**Record of Decision**  
**Syracuse China Site**  
**Town of Salina, Onondaga County**  
**Site Number 7-34-053**

**March 1996**

**DECLARATION STATEMENT - RECORD OF DECISION****Syracuse China Inactive Hazardous Waste Site  
Town of Salina, Onondaga County, New York  
Site No. 7-34-053**Statement of Purpose and Basis

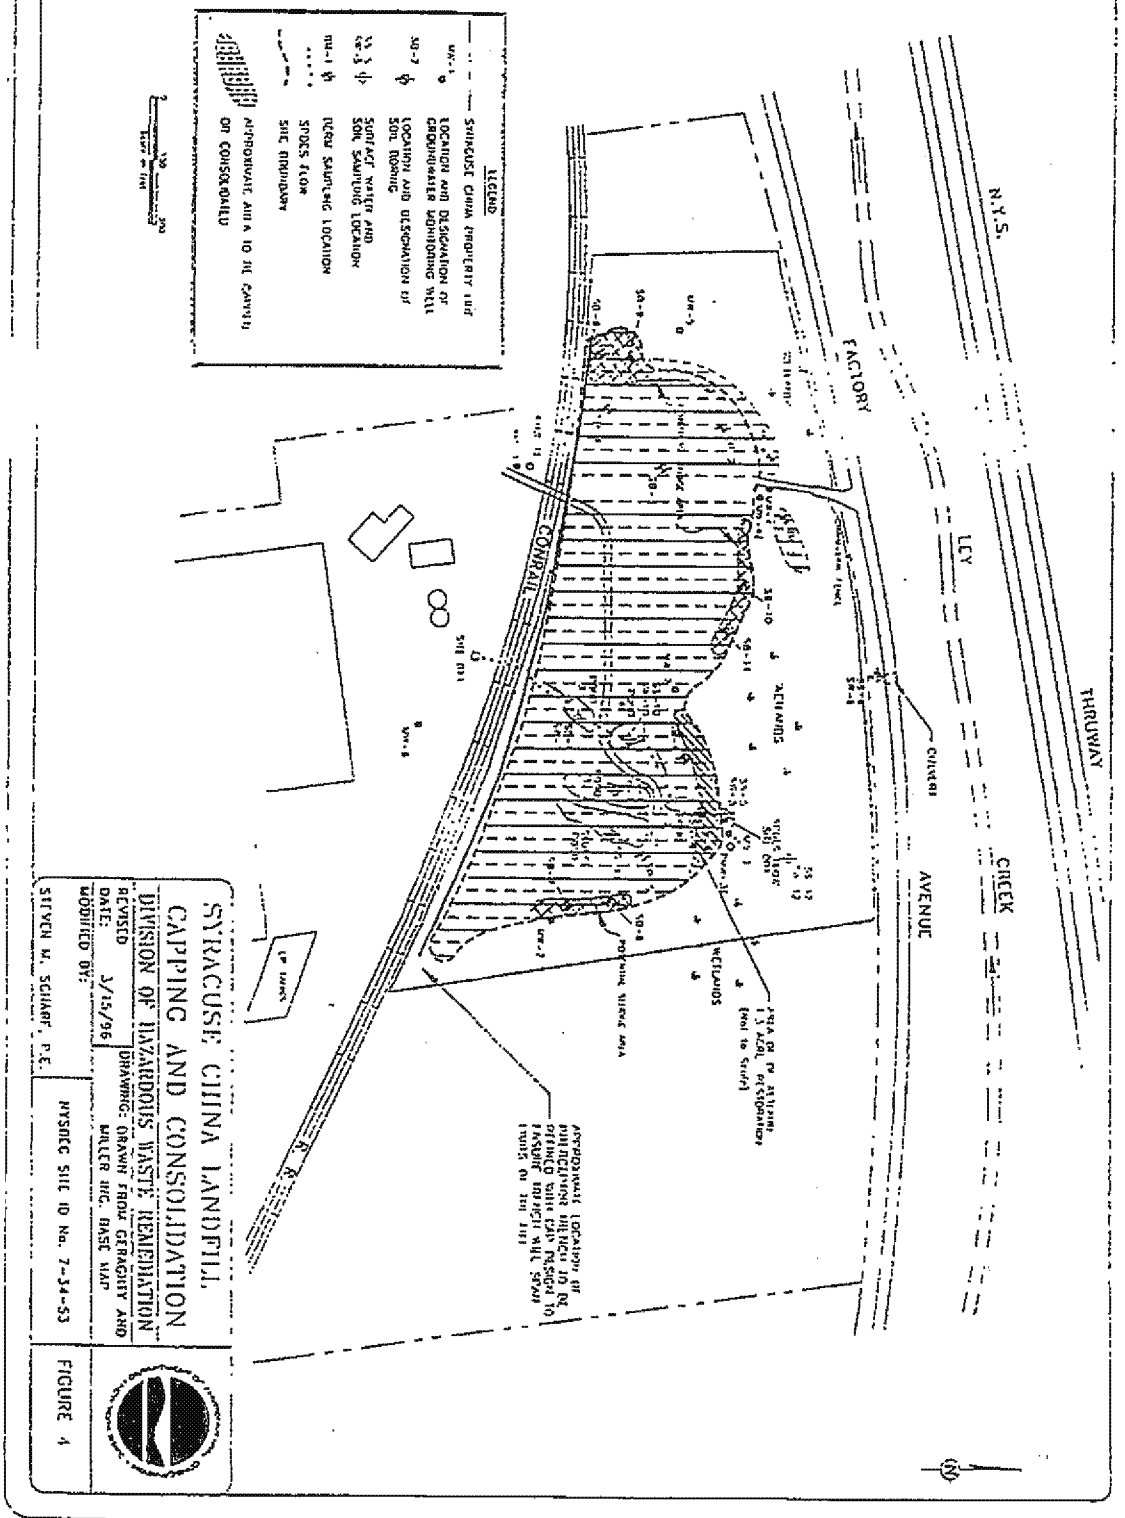
**COMMENT 10:** What is happening to the rest of the wetlands besides the 1.3 acres to be restored?

**COMMENT 12:** How many acres is the landfill?

**RESPONSE 10:** Based upon the current delineation, approximately six acres of the wetland surrounding the landfill (as shown on Figure 3 of the ROD) will be excavated to address lead contaminated sediments. There will be additional testing of wetlands during remedial design, to better define the area and the depth to be excavated. Lead contamination is expected to be found in the top foot of the wetland sediments on average .

- RESPONSE 12:** The landfill area, as shown on Figure 3 of the ROD, is approximately 13 acres.
- COMMENT 13:** What is the next step?
- RESPONSE 13:** The NYSDEC has evaluated the comments received and prepared this responsiveness summary. The Proposed Remedial Action Plan (PRAP) has been finalized into the Record of Decision (ROD). Once the ROD is issued the NYSDEC will begin negotiations with Syracuse China to implement the selected remedy.
